SUBJECT: Limerick Generating Station, Units 1 & 2
Additional Information for Auxiliary Systems
Branch Regarding SER Open Issue #2 (Tornado
Missile Effects on Ultimate Heat Sink)

RESPONSES TO QUESTIONS AND REQUESTS FOR
ADDITIONAL INFORMATION ON
NUS-4507 REPORT

"LIMERICK GENERATING STATION UHS EXTREME WIND HAZARD ANALYSIS"

September 1984

Figure 1. Limerick Hazard Curves for Hurricane and Straight Winds

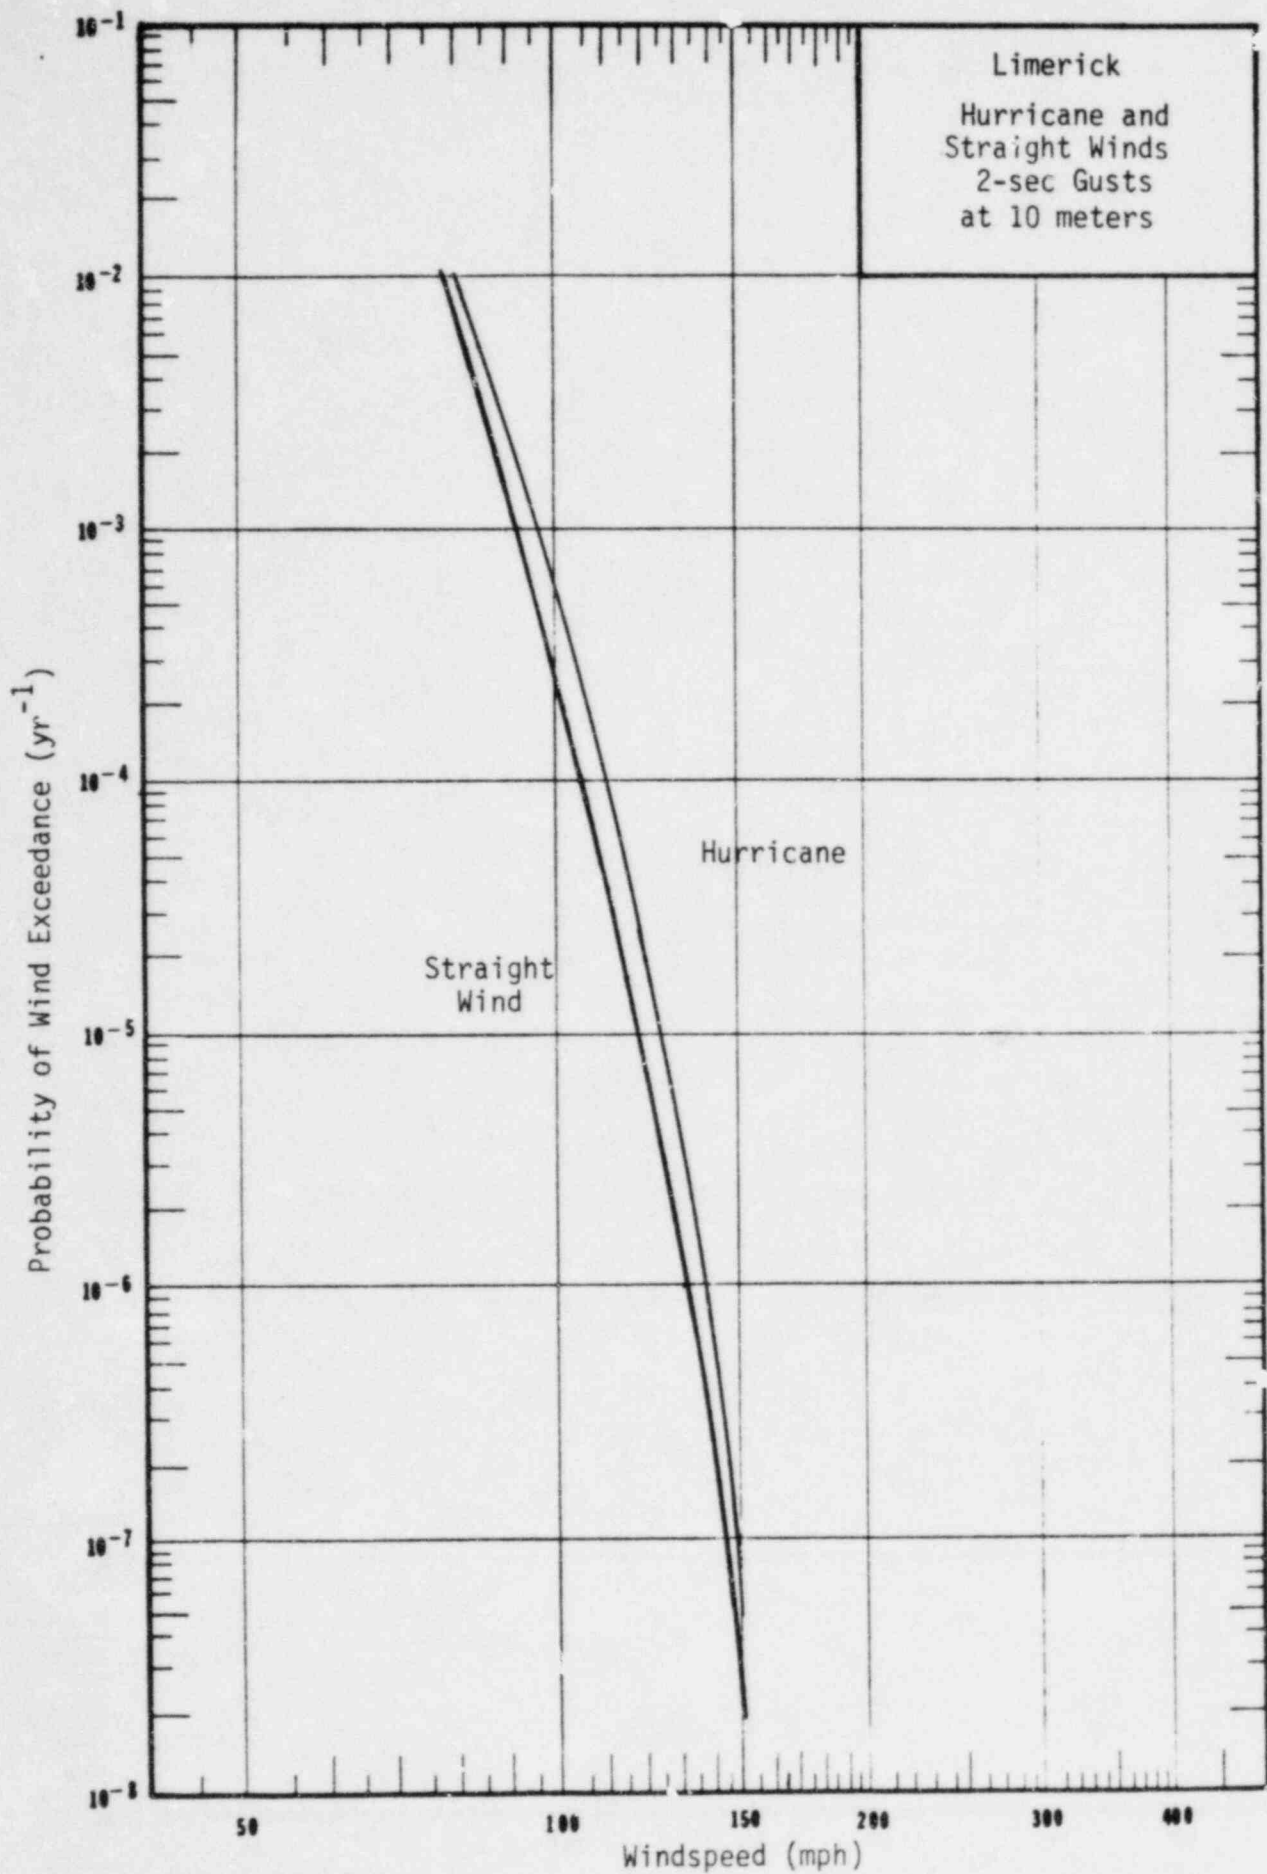
Q.6 What is the value of the hurricane and straight wind speeds at an elevation of 33 ft. which correspond to the nominal failure of the cooling towers? Can it be shown that the probability of failure of the cooling towers due to missiles borne by straight winds and hurricanes with speeds less than this value is negligible when compared to a frequency of 10^{-6} per year?

These frequencies are identical to the 78 and 102 mph data and are slightly conservative for the 70 mph data point in NUS-4507 [3]. The resulting curve is given in Fig. 1.

Table 1 summarizes these calculations and the resulting windspeeds for exceedance probabilities 1×10^{-1} to 1×10^{-6} per year. Figure 1 illustrates the straight-wind frequencies. These windspeeds correspond to 2-sec gusts, which are conservatively assumed to be of sufficient duration to fail the cooling towers.
